Alex Reizman, PE  
501 Herondo Street  
Hermosa Beach, CA 90254

June 14, 2018

Subject: Greenbelt Infiltration Project between Herondo and 2nd Street – Groundwater Issue

Figure 1 – Historic High Groundwater Level

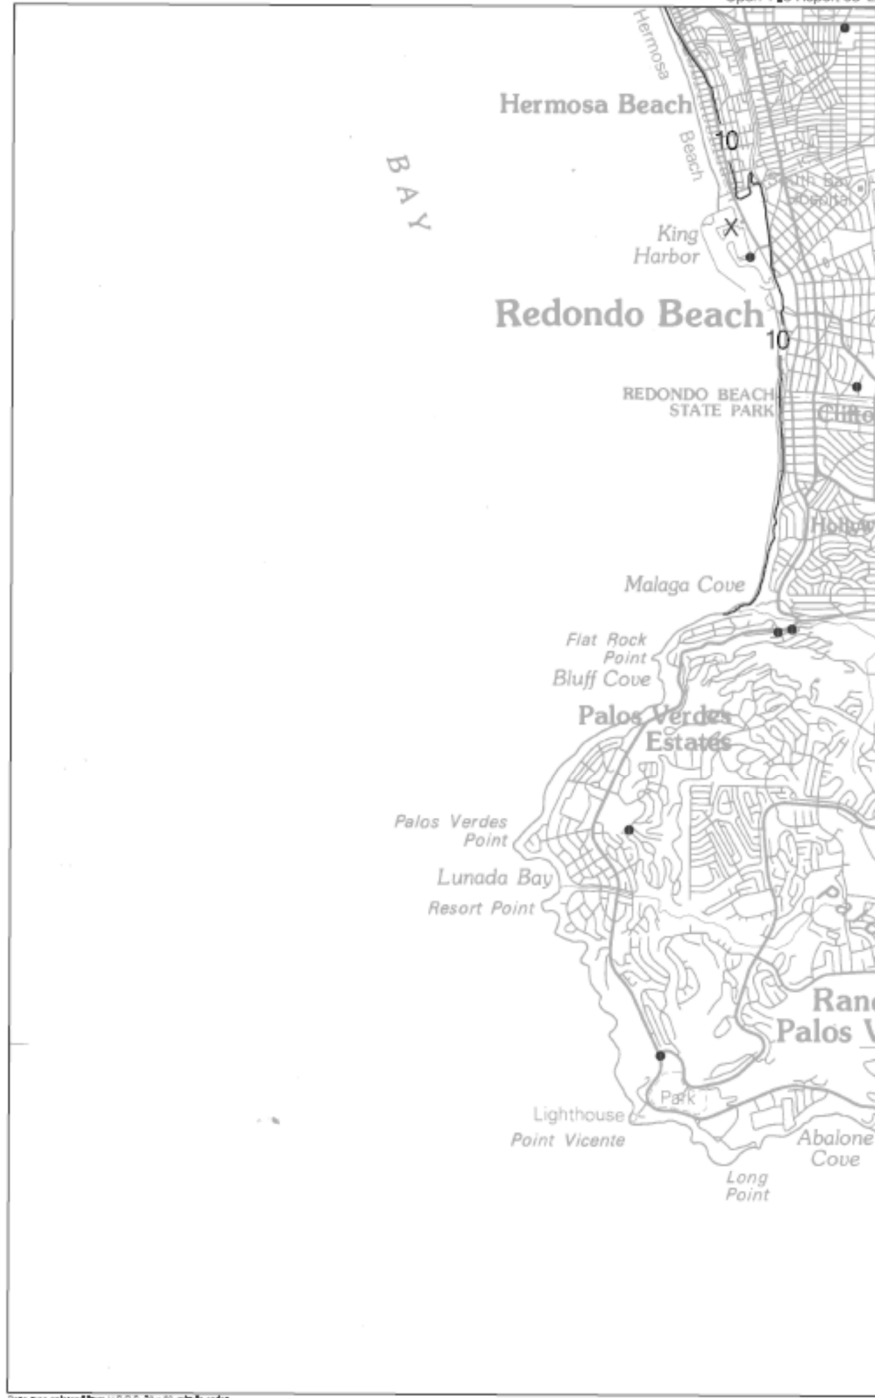
The historic high groundwater level for the proposed Greenbelt infiltration project location is only 10 feet below ground surface level. This is documented in reference #4, report plate 1.2 (see Figure 1 of this letter). The use of historic groundwater level would not allow for an infiltration project. The regulations go on to say that "existing groundwater data may also be used to verify the seasonal high groundwater elevation is greater than 10 feet...". The definition of seasonal high groundwater level is: The elevation to which the ground or surface water can be expected to rise due to a normal wet season.

Figure 2 – Groundwater Well Close to Proposed Project (Well 704E is nearest)

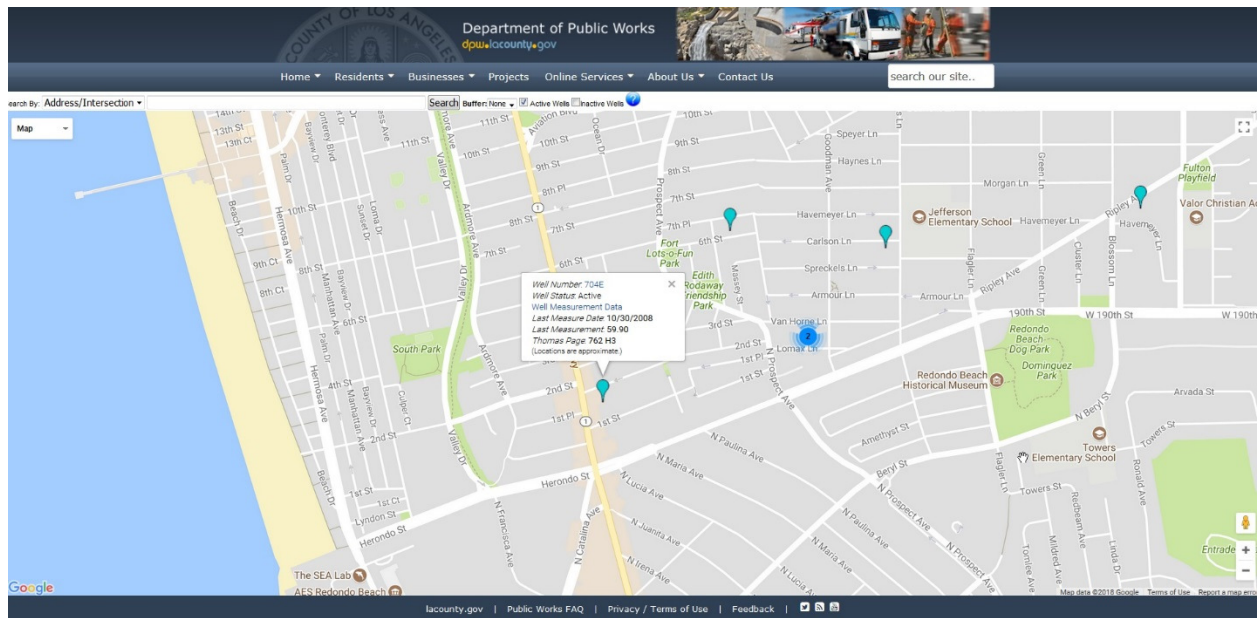
Fortunately, extensive existing groundwater data is available for the Hermosa Beach area. For example, the Water Replenishment District of Southern California (WRD) publishes yearly Regional Groundwater Monitoring Reports which show groundwater trends in the Los Angeles basin (see Reference 5). Table 1 of this letter summarizes the groundwater level at Hermosa Beach, based on these yearly reports. A monitored well 704E, located close to the proposed Greenbelt project, as shown in Figure 2, was operational until 2008. The data is available from Reference 6. The groundwater level data from that well is shown in Figure 3.

Figure 3 – Groundwater Level from Well 704E

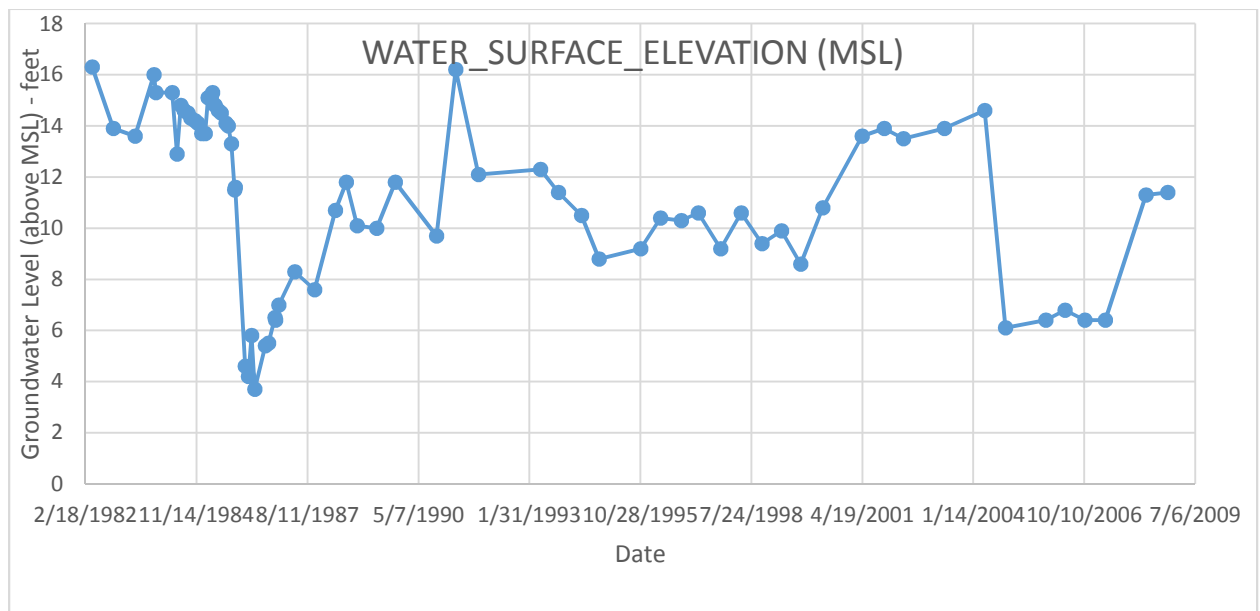
Based on the above documented data gathered over the last 35 years, the seasonal high groundwater is estimated to be 15' above Mean Sea Level (MSL). This groundwater level was reached in 2008, 2004, 1991, and 1985. A fairly frequent occurrence by any standard. The Greenbelt ground elevation at the proposed infiltration site is 30' (above MSL). Therefore, the seasonal high groundwater level is  $30' - 15' = 15'$  below ground surface. It is important to note that the site specific Geosyntec groundwater value of 25' below ground surface (Reference 1), is a snapshot in time and should not be considered as representative of seasonal high groundwater values. The regulations specifically recognize this, and therefore only allow the use site specific explorations if historic and existing data is not available. And even then, with certain limitations and required adjustments for seasonal effects.
